# CITY OF CANNON BEACH

## **WATER RESILIENCY PHASE 1 – SEISMIC IMPROVEMENTS**

### **ADDENDUM TO ITB - 2**

DATE: August 22, 2023

SITE & EROSION CONTROL PLAN -  
MAIN RESERVOIR

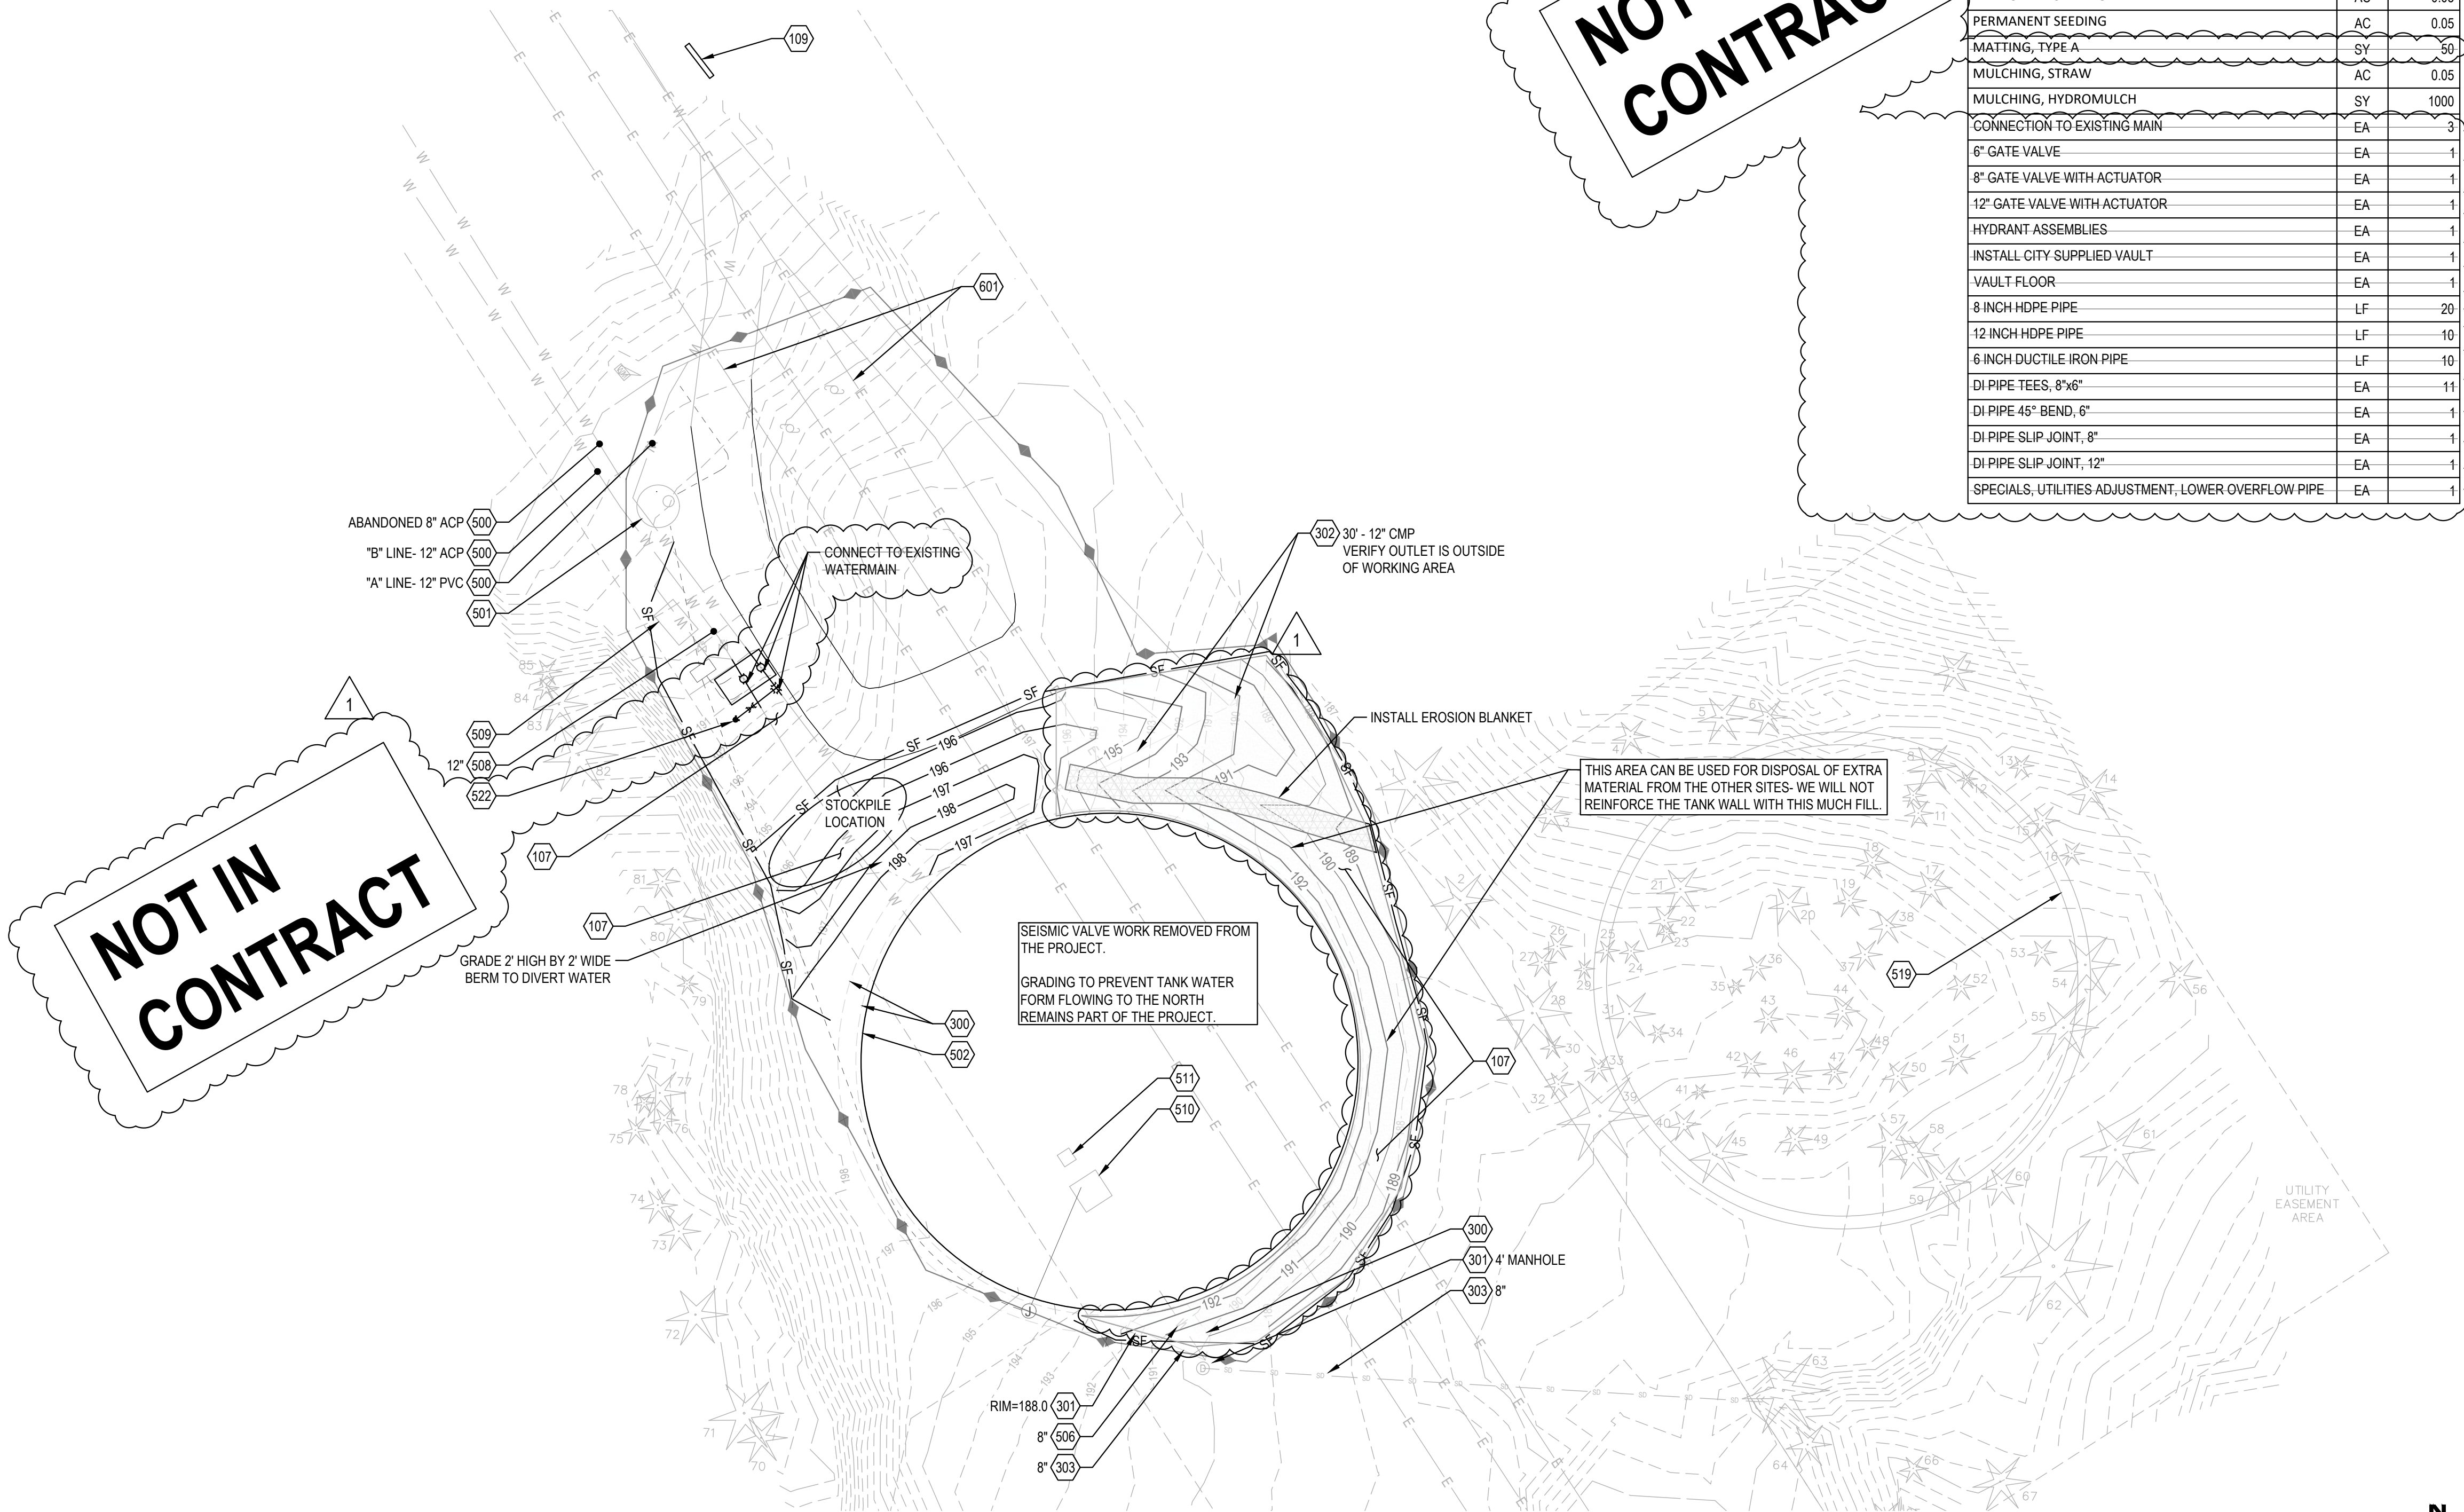
1. Please see revisions to Drawings C100 and C101 (attached within revised plan set) which remove any piping work from the Main Reservoir.
2. Please see revisions to the timeline in Spec Section 00 01 20 (attached) to accommodate lead time for actuators.
3. Please see revisions to the Instructions to Bidders in Spec Section 00 21 13 (attached).
4. Q: What permits will be required by the City and the associated permit fees for this work?

10. Q: Can you specify the approved fittings/adaptors required for connecting the existing Asbestos pipe to the new HDPE pipe on Drawings C100 (Main Reservoir) and C106 (Isolation Valve 4)?

16. Q: On sheet C100 there are 8” and 12” DI PIPE SLIP JOINTS – What are those?

A: Romac or similar repair clamp stainless steel. Contractor to verify OD and coordinate with supplier.

VAULT AND VALVE DETAILS - NORTH  
RESERVOIR

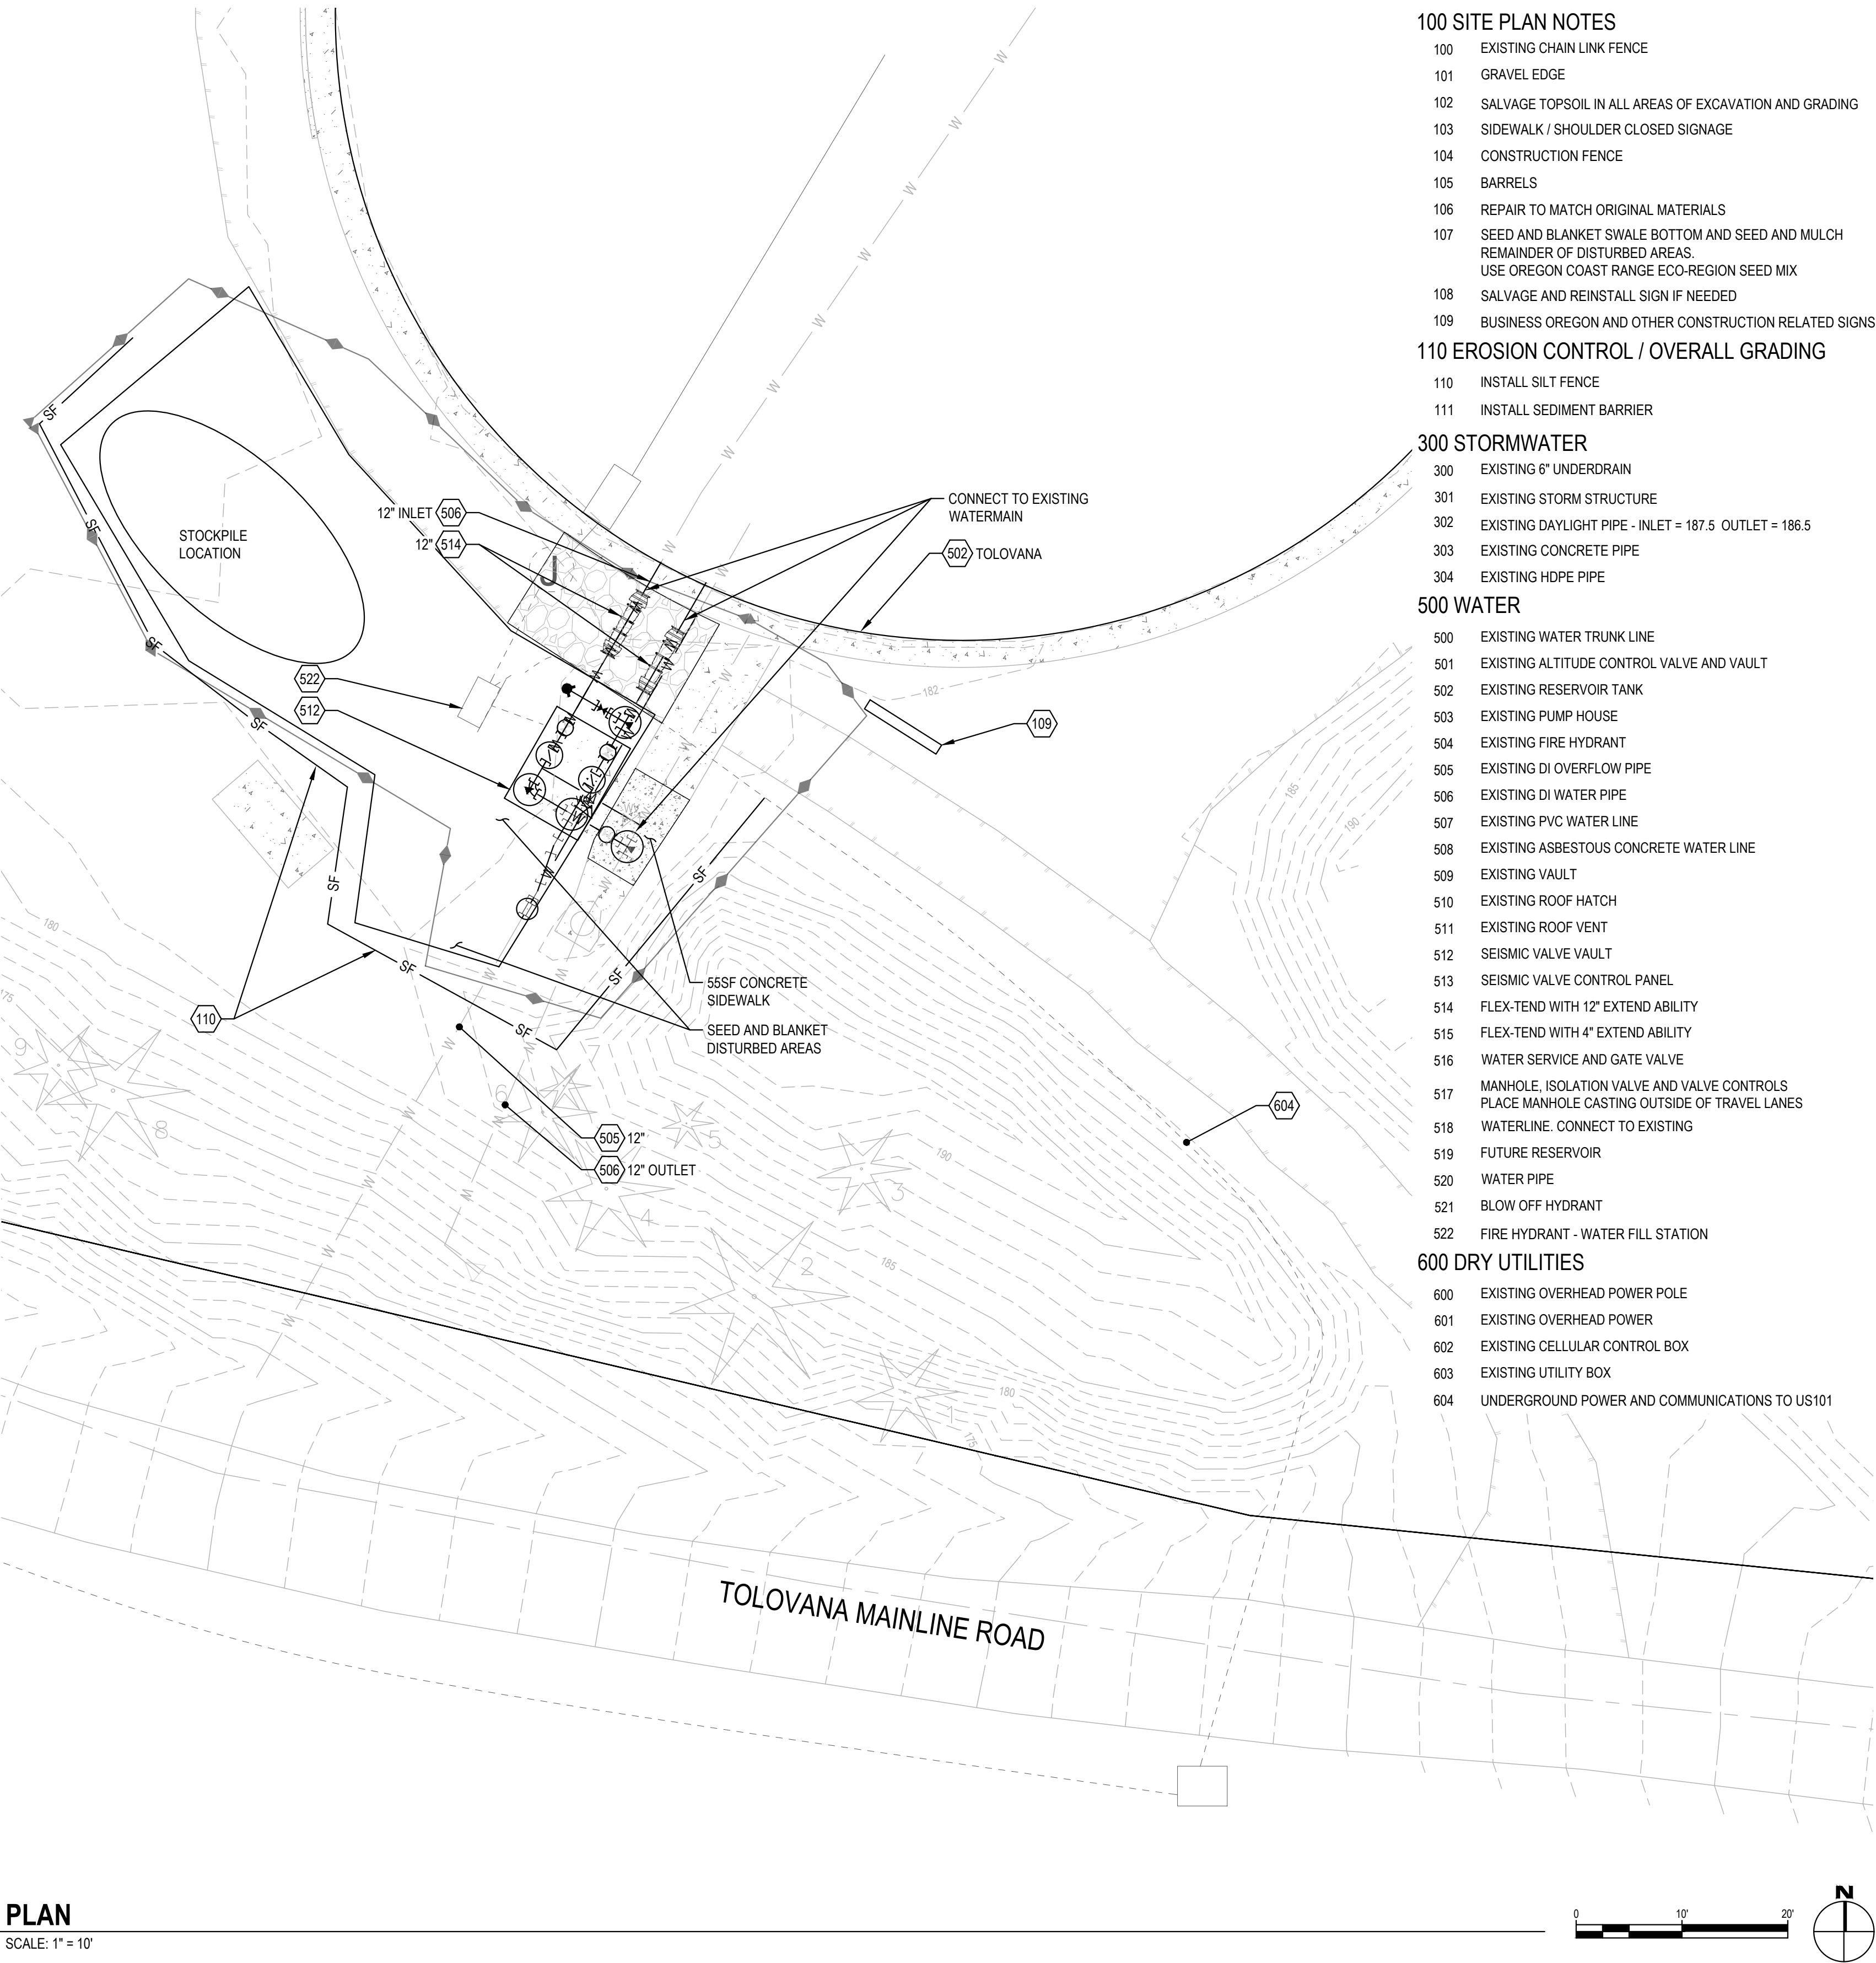
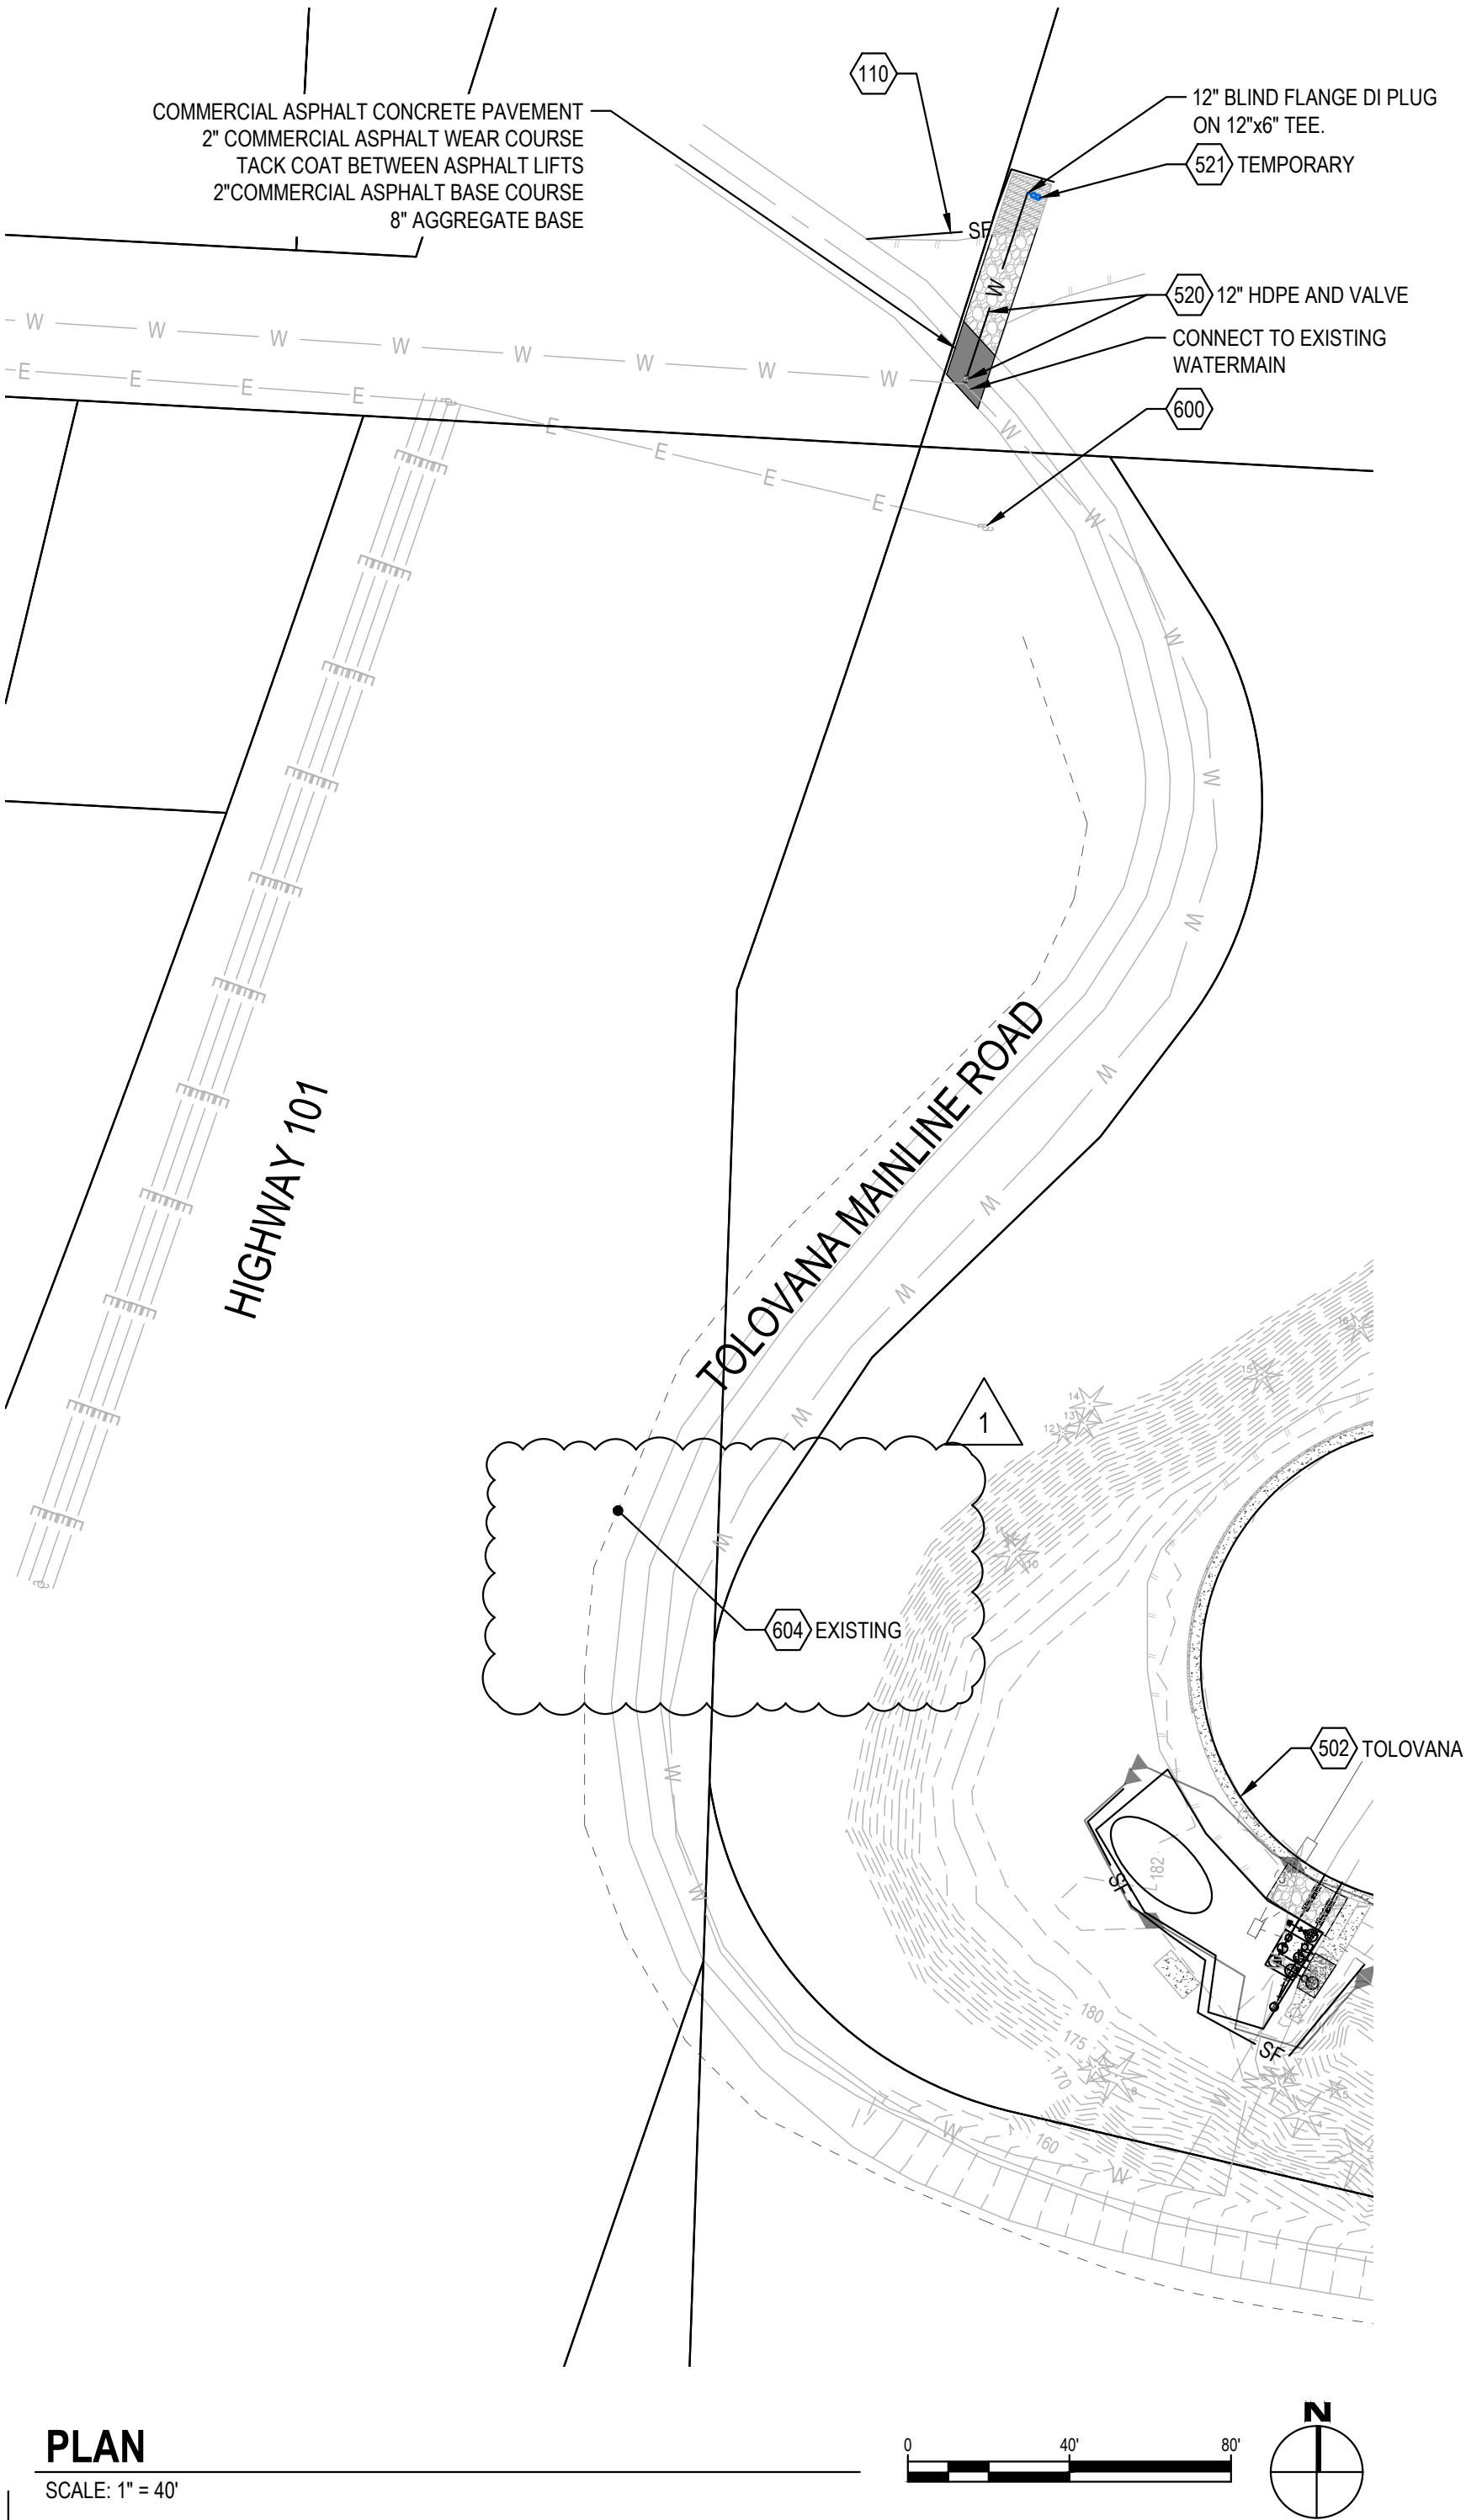
11. Q: In reference to the replacement gate valves at the North Reservoir (Drawing C103), can one of the clarifications be provided? 1.) The Brand and Model of existing valves, 2.) A measurement of the valve width from flange to flange, or 3.) Validation that the approved valve manufacturers and models can be installed within the existing space between flange connections without significant alteration to the connecting pipes and flanges?

A: 1. Outlet valve

2. Inlet valve

3. Contractor to verify all information and to verify gate valve they are providing will work in the space provided
